TO: Mayor & City Council  
FROM: Mary Lou DeWitt, Comm. Dev. Zoning Specialist  
SUBJECT: **Palmer Bus Service Site Plan Review**  
DATE: September 23<sup>rd</sup>, 2024

Re: Palmer Bus Holdings, LLC  
Site Plan Review  
WSB Project No. 026552-000

We have reviewed the preliminary plat documents, revised 08/27/24, by Gradient Engineering, and have the following comments:

**Hydrant Required Per 2020 MN State Fire Code**

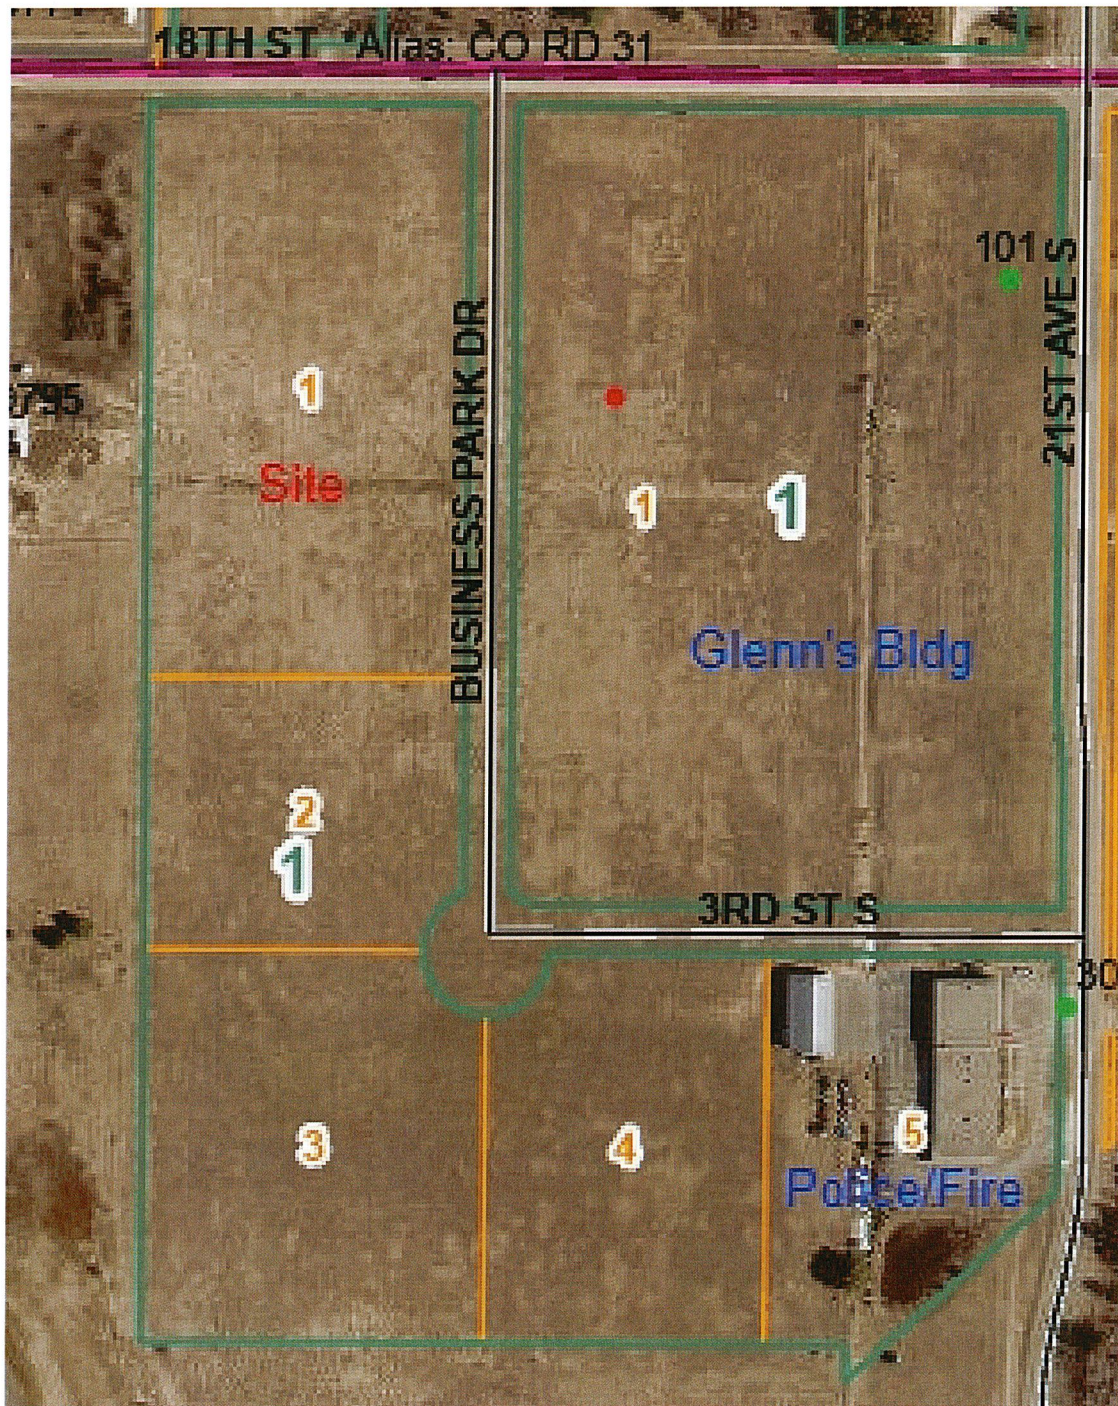
14. 507.5.1.1 Hydrant for standpipe systems.

Buildings equipped with a standpipe system installed in accordance with Section 905 shall have a fire hydrant within 100 feet (30 480 mm) of the fire department connections.

**Lock Box Required Per 2020 MN State Fire Code**

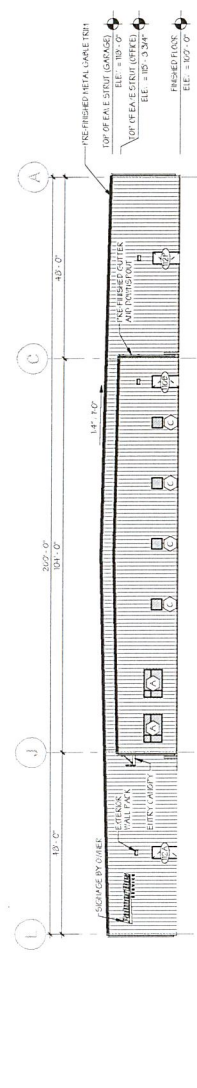
15. 506.1 Where required.

Where access to or within a structure or an area is unduly difficult because of secured openings or where immediate access is necessary for life-saving or fire-fighting purposes, the fire code official is authorized to require a key box to be installed in an approved location. The key box shall be of an approved type and shall contain keys to gain necessary access as required by the fire code official

C2.0

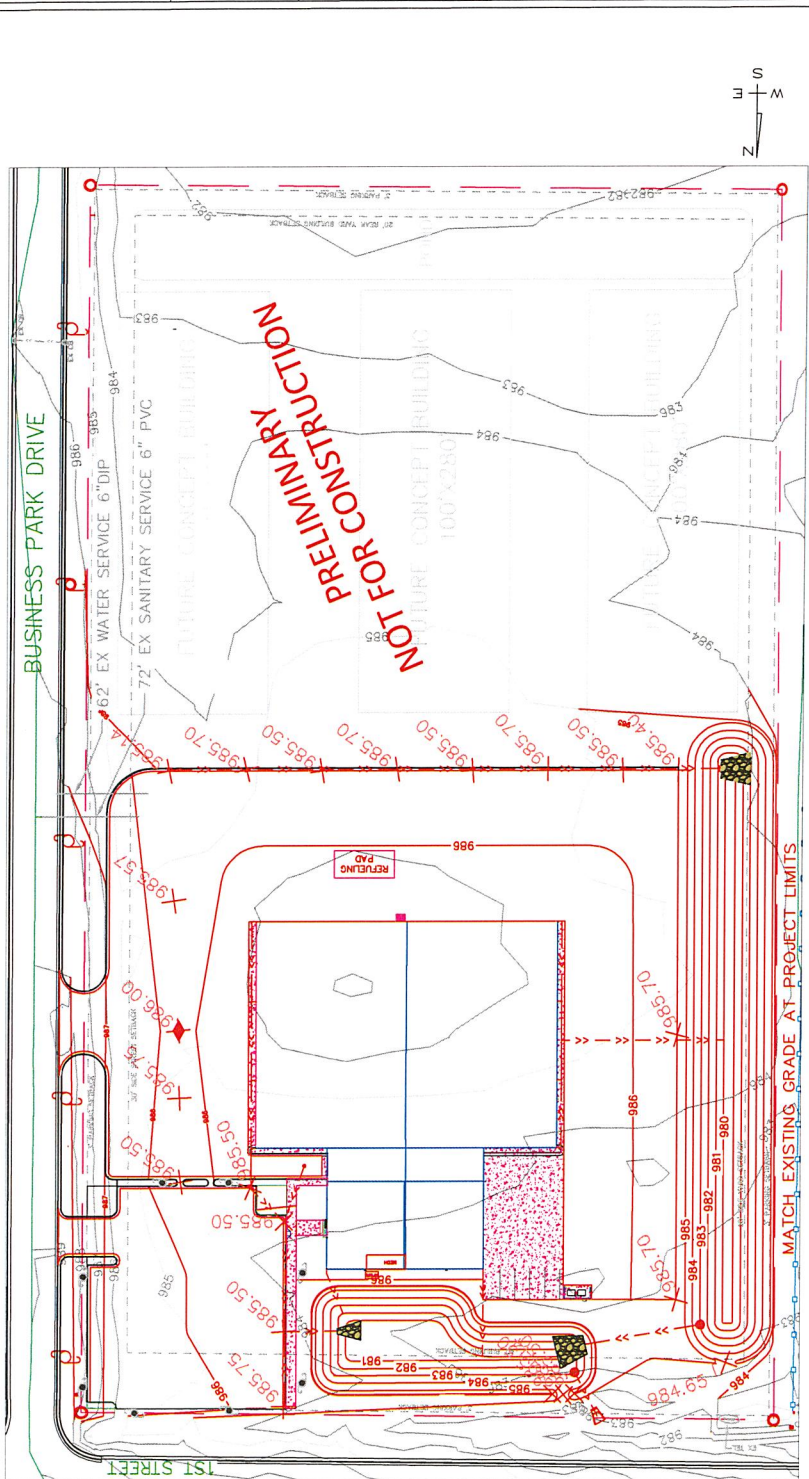
10. Identify curb type and indicate on plans where tip out curb will be necessary. The grading plan shows a curb separating the two parking lots, but the grading plan shows stormwater draining from the south lot to the north lot. With the curb present, its not clear how this will work.
11. The scale on the grading plan is 80 scale, this is not a standard scale – please change to a standard scale.
12. I would like more of an opportunity to talk about the grading of the southern lot. Are the grades set to balance earthwork? It seems as if there could be some additional grading modifications to eliminate some of the storm catch basins in the southern curb line.

C2.2

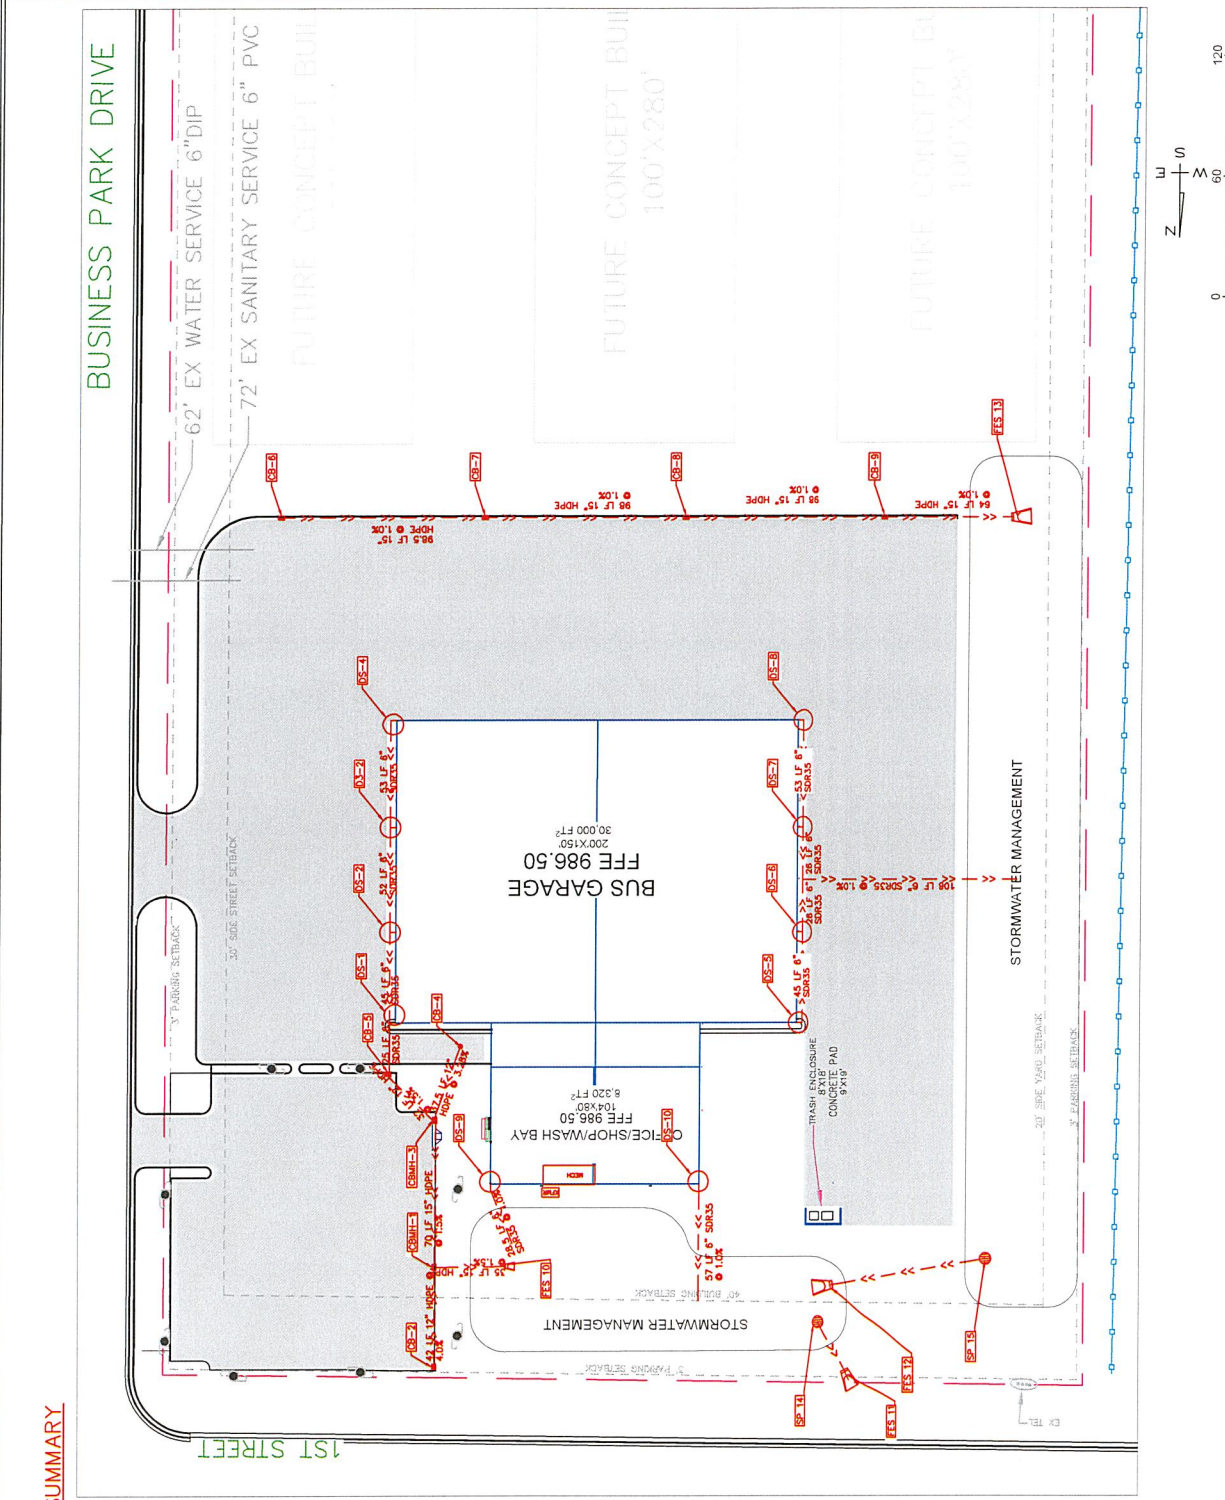
4. Include detail on inlet protection devices.
5. Include detail of HDPE flared-end section.
6. Submit design calculations for the 1-year storm event.
7. Provide rational method storm sewer sizing calculations to confirm storm sewer is sized for a 10-year storm event.
8. Verify CBMH 3 diameter will work with the two pipe angles coming into the structure.
9. Following the construction of infiltration areas, field testing of the area shall be completed by the project proposer and results submitted to the City for review.
